UNITED STATES PATENT AND TRADEMARK OFFICE

APPLICATION NO.	FILING DATE	FIRST NAMED INVENTOR	ATTORNEY DOCKET NO.	CONFIRMATION NO.
10/822,007	04/12/2004	Hideaki Shimoda	251774US2	1570
22850	7590	08/08/2005	EXAMINER	
OBLON, SPIVAK, MCCLELLAND, MAIER & NEUSTADT, P.C. 1940 DUKE STREET ALEXANDRIA, VA 22314			GLENN, KIMBERLY E	
			ART UNIT	PAPER NUMBER
			2817

Office Action Summary

DETAILED ACTION

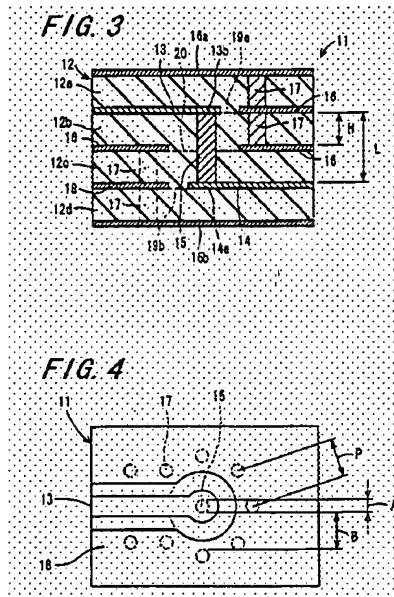
Claims 1-4 and 15 are rejected under 35 U.S.C. 102(e) as being anticipated by Shirasaki US Patent 6,700,789 B2.

Shirasaki disclose in figures 3 and 4, a high frequency wiring board comprising a first conductor line 13, the width of the circular edge portion 13b thereof being different from the width of remaining portion thereof; and a second conductor line 14 connected to the edge portion of said first conductor line. The first and second high conductor lines 13 and 14 are disposed in different layers of a dielectric substrate 12 respectively. The edge portion of the first conductor line is arranged to overlap with the second conductor line. A through conductor 15 is provided to connect said edge portion 13b of said first conductor line 13 to the edge portion 14b of said second conductor line 14. The second conductor line has circular edge portion 14b that has a width, which is different from a width of remaining portion thereof. Conductors 6 are provided to for shortening a distance between a ground conductor 16 and first conductor line 13. The edge portions of first and second conductor lines overlap each other. (Column 4 line 19 through column 6; line 13)

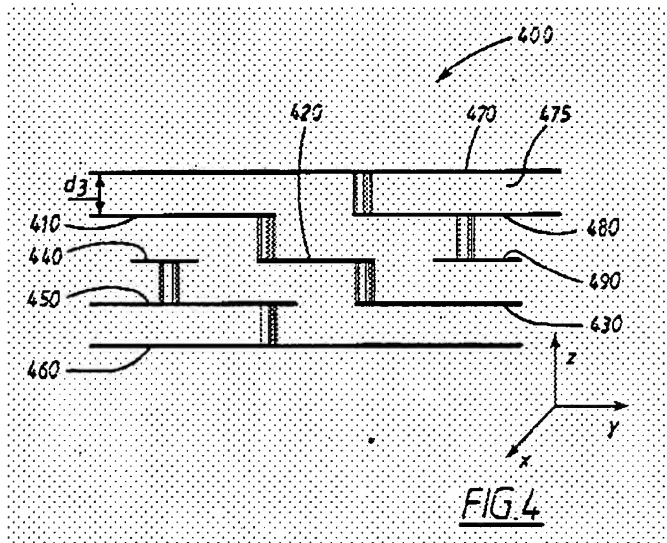
Claims 5,10,11 and 14 are rejected under 35 U.S.C. 102(B) as being anticipated by Harju et al US Patent 6,522,214 B1.

Harju et al disclose in figure 4, a transmission line arrangement comprising a first conductor section 410 in a layer of a dielectric substrate 475; a second conductor section 430 in a different layer of a dielectric substrate; a third conductor section 420 provided in a layer between said first conductor section and said second conductor section wherein one edge of said third conductor section 420 is overlapped with said first conductor section 410 and another edge thereof is overlapped with the second conductor section 430, a first connection conductor for connecting said first conductor

section 410 to the one edge of said third conductor section 420 and a second connection conductor for connecting said second conductor section 430 to the another edge of said third conductor section 420. Harju et al further disclose a conductor 450 for shortening a distance between said first conductor section and a ground conductor 460. (Column 7; line 8 through column 9; line 3)

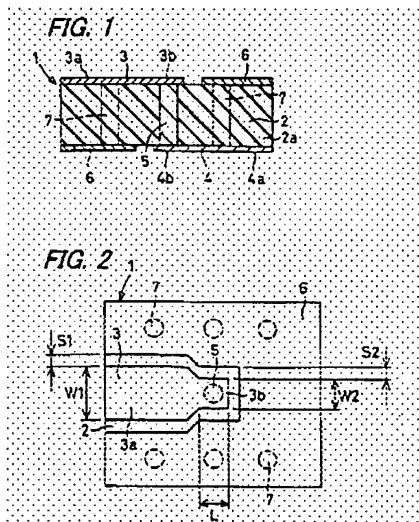
Claims 12 and 13 are rejected under 35 U.S.C. 102(e) as being anticipated by Shirasaki US Patent 6,726, 488 B2.

Shirasaki disclose in figure 1 and 2, a high frequency wiring board comprising of a first line conductor 3 having a width of an edge portion 3b thereof being different from a width of another portion thereof; and a second line conductor 4 different from the first line conductor 3, which is connected to the edge portion of the first line conductor. The first and second line conductor disposed in different layers of a dielectric substrate 2 respectively. The edge portion 3b the first line conductor is arranged to overlap with the second line conductor; and a through conductor 5 is provided to connect said edge portion of said first line conductor to said edge portion of said second line conductor. (Column 5; line 7 through column 6; line 56)
